**MINUTES OF THE MEETING**

**December 6, 2007**

**Seattle  
Design  
Commission**

- Fire Station 39—Lake City
- Woodland Park Zoo—West Entry
- Woodland Park Zoo—Penguin Exhibit
- Terminal 30—Alaskan Way South
- University Link—UW Station and Pedestrian Bridge

### Terminal 30 Additional Improvements-Conceptual Design

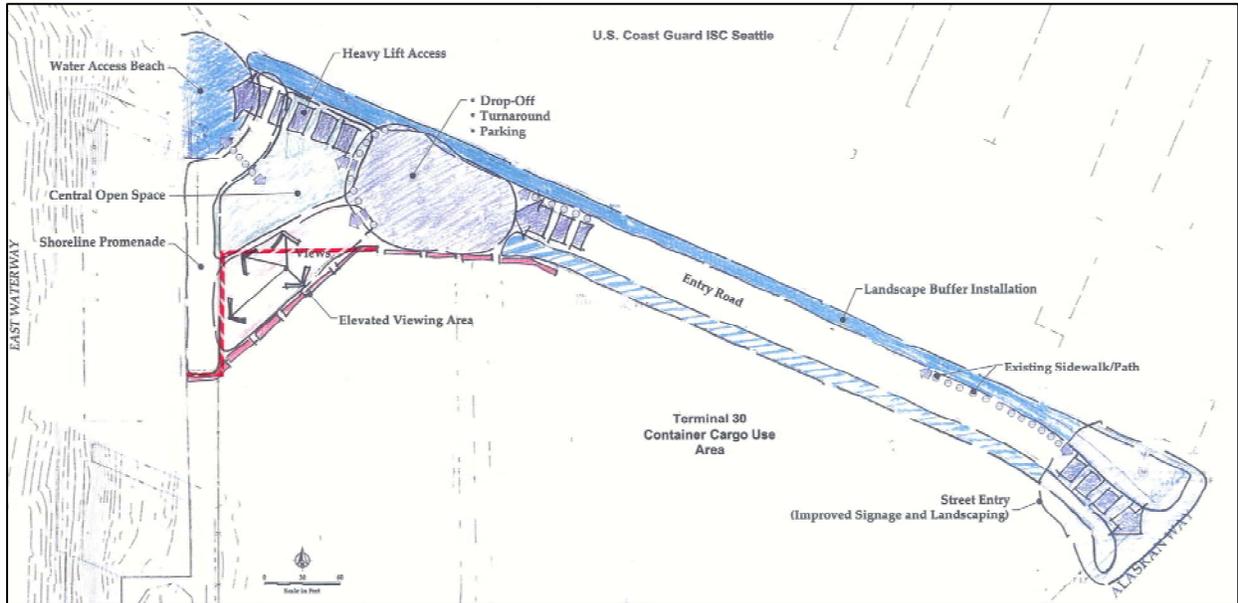
- Two different view access, potential for trails
- Concern with lack of parking (at Pier 24) for public to get there and for those who are not able to bike
- More police concerns
- Concerned about taking away triangle; is it worth losing it? Increased dead end potential; need to see how it evolves

- Will Pier 24 improvements continue?
  - No.
- Is there going to be any surveillance possible of Terminal 24? Office function?
  - There is surveillance at site.
- Could there be access or public trail?
- Terminal 30—is the height recommended to see over container ships? What are the views from the groundplane?
  - Attract more people that would draw attention to people at Terminal 30, but the new site could also contain a view structure.
- Safety questions in terms of visual access regarding Pier 24 to see if green mitigation area has potential to evolve? Site to the south could contribute to site of amenity
- With the bike path going to Terminal 24, it seems like more maneuverability exists
  - Bridge was at grade
- Are there opportunities to increase safety at Terminal 30?

- Would you look at providing narrow access to Terminal 24?
- What is the nature of the shoreline south of the yellow zone? Does the Port own land south of yellow zone?

- Maps of all the access points at human-scale
  - Wanted to check dipstick check and then begin to show design concepts
- Terminal 30—taking triangular piece away, concerned for degrading promenade and the dead end

- The triangular piece could become an elevated piece
  - Condition is not safe
- Is the Coast Guard going to stay?
  - Yes, they will stay.
- Would like maximize waterfront access which will strengthen public benefits via design view

- Show where and how visitors would park
- Are the public benefit commensurate with giving up the
- Clarity of urban design related

- Have found stolen cars. Have not had any incidents; have emergency phones at various sites. Multiple in and out routes.
- Drainage stormwater—struggling to introduce green corridor feature (Terminal 35 stormwater drainage feature)

Pedestrian Bridge vs. Tunnel comparison:

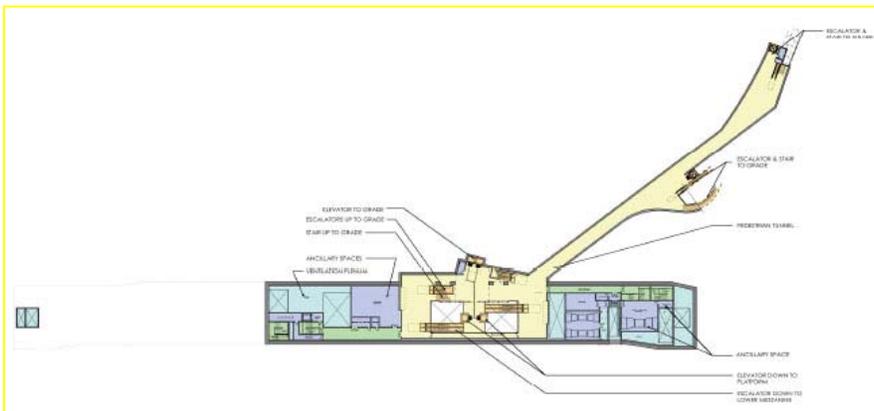
- What is cost of tunnel vs. bridge?
  - o Bridge is cheaper by several million
- When line is extended, how does it sequence?
  - o Build from north to connect to this station
- Likes bridge, it's not a new feature at the campus. Likes long arc, cost differential.
- Likes bridge for reasons already stated. Also it humanizes the intersection.
- **Commission unanimously prefers the bridge instead of the tunnel because it supports the pedestrian environment, stitches to campus, is in itself a compelling feature, lower cost, easier to construct and more sustainable.**
